<b>TO:</b>	His Worship Mayor Dan Ruimy and Members of Council	<b>MEETING DATE:</b>	February 7, 2023
		<b>FILE NO:</b>	2020-062-DVP 2020-062-DP
<b>FROM:</b>	Chief Administrative Officer	<b>MEETING:</b>	C o W
<b>SUBJECT:</b>	<b>Development Variance Permit and Development Permit Unaddressed lot (PID 008-130-493), 22347 117 Avenue &amp; 22349 North Avenue</b>

Re: **ADP Response Letter**  
Lougheed & North Avenue Residences, Building A  
22347 to 22351 North Avenue

A5.5a

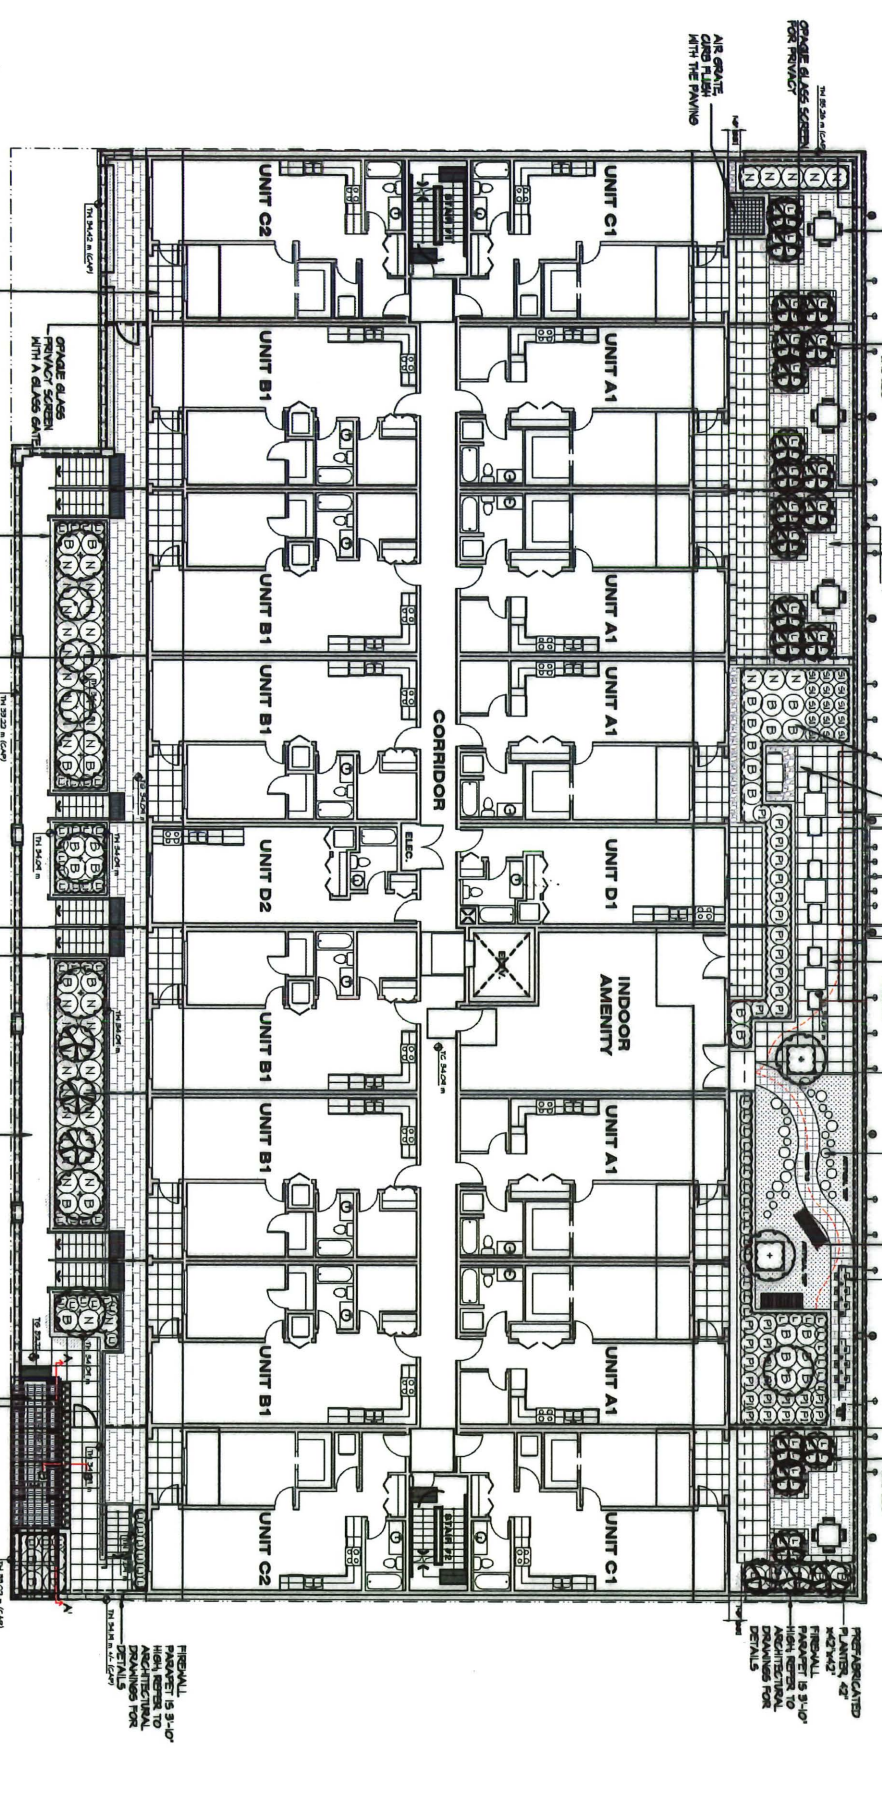
5. The final artwork proposed along 117 Street, conceptually shown on drawing A5.5a, shall be submitted to and accepted by the Director of Planning or their delegate prior to fabrication. The artwork is to be installed before final occupancy is granted to the commercial/office component of this project.

The final design of the metal artwork is subject to the approval of the Director of Planning or their designate, prior to fabrication and installation. Please refer to the Development Permit issued by Council for further information.
